AC22260: Willow Way, Sydenham – Surface and Foul Water Drainage Strategy – Technical Note

AC22260-ABS-XX-XX-RP-C-5801

Appendix A – LLFA Comments

Appendix B – Intensive Roofing System and Layout

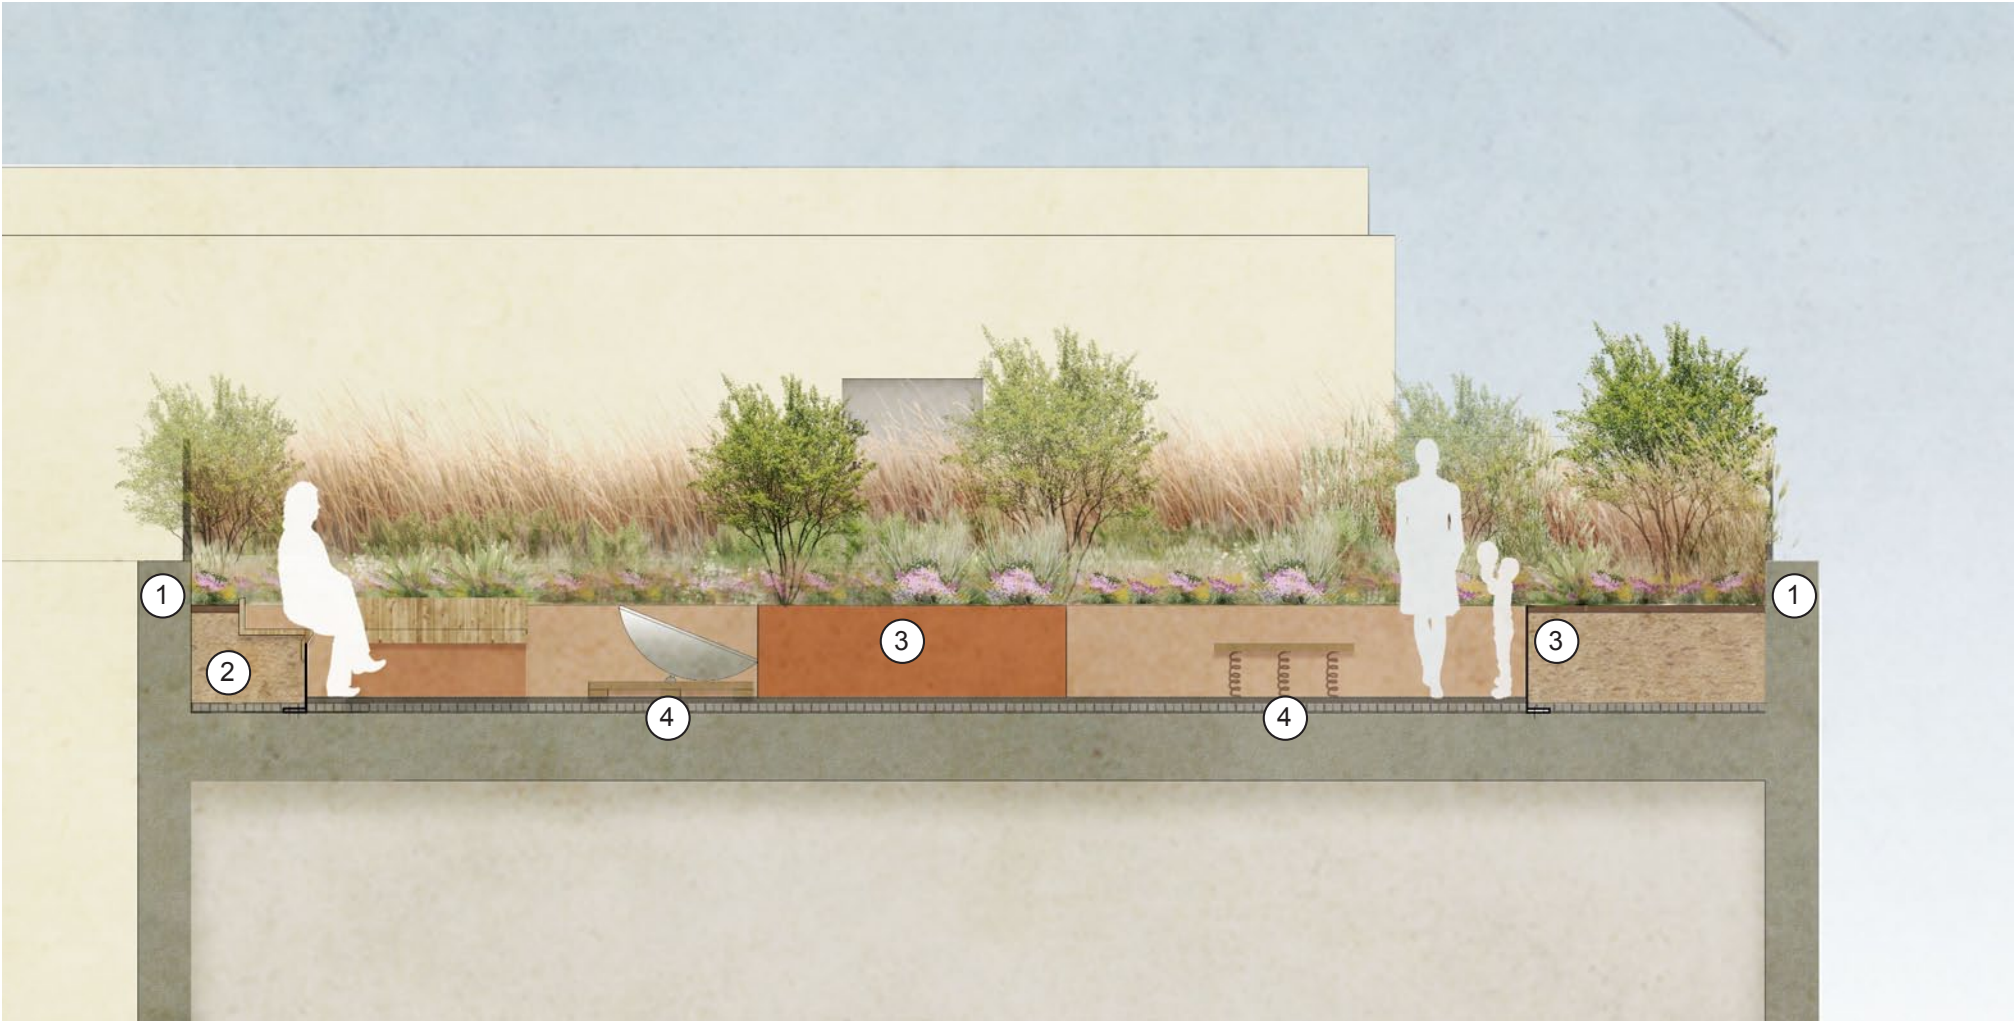
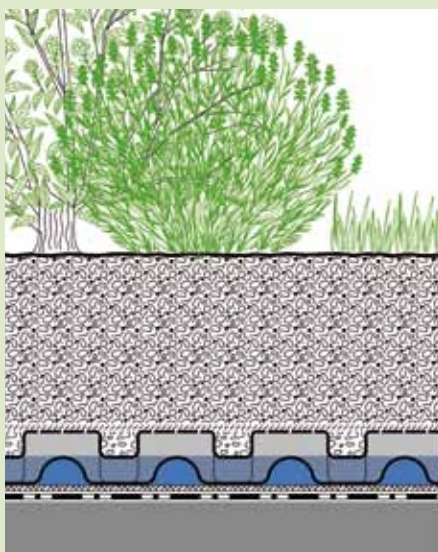
2.1. Demonstrates that they have considered smaller scale rainwater harvesting features.

- The applicant has not provided sufficient justification for the non-inclusion of rainwater harvesting techniques. The applicant should consider the use of water butts / raingardens.

However, there are some areas of roof which do not have the extensive green roof elements we have shown on our drawing within the report. These areas are a communal roof space for the residents and include intensive planting built up using the ZinCo Green Roof system or similar. These are acting as Rain Gardens in these areas and contain a layer to hold back surface water within the build up to irrigate these areas during drier periods of little or no rain.

Therefore further use of the roof water has been considered and is being used, as demonstrated by the additional information contained within Appendix B.

Appendix F – Drainage Layout

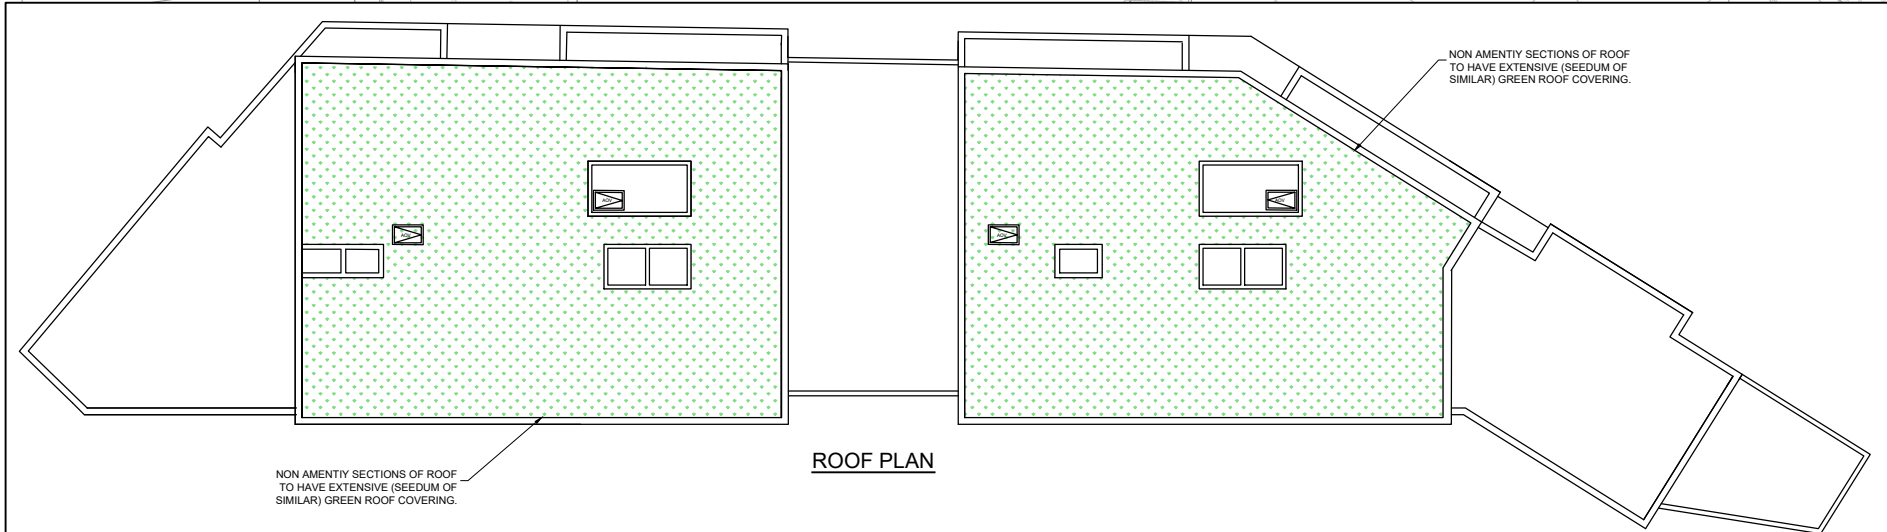
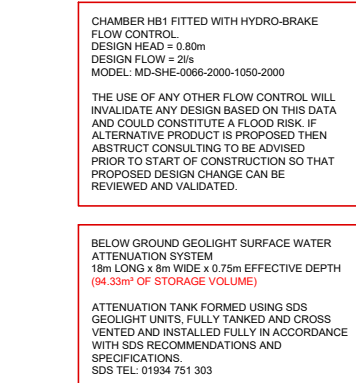
- 2.6. Demonstrates updates to the drainage calculations (detailing the changes made) to ensure the half-drain times are reduced to less than 24 hours, to ensure that the proposed drainage strategy will remain operational in the case of consecutive storm events. Demonstrates where the exceedance flows are on a drawing.**

- The drainage calculations provided state that the "Half Drain Time has not been calculated as the structure is too full". The applicant is required to provide a drawing showing exceedance flows.

Exceedance Flow Arrows have been added to the Drainage Layout AC22260-ABS-XX-XX-DR-C-5100 which can be found in Appendix F.

P02	05/05/23	MH	MH	EXCEEDANCE FLOW ARROWS ADDED.
P01	16/12/22	MH	MH	PRELIMINARY ISSUE.
Mark	Date	By	Chkd	Revision notes
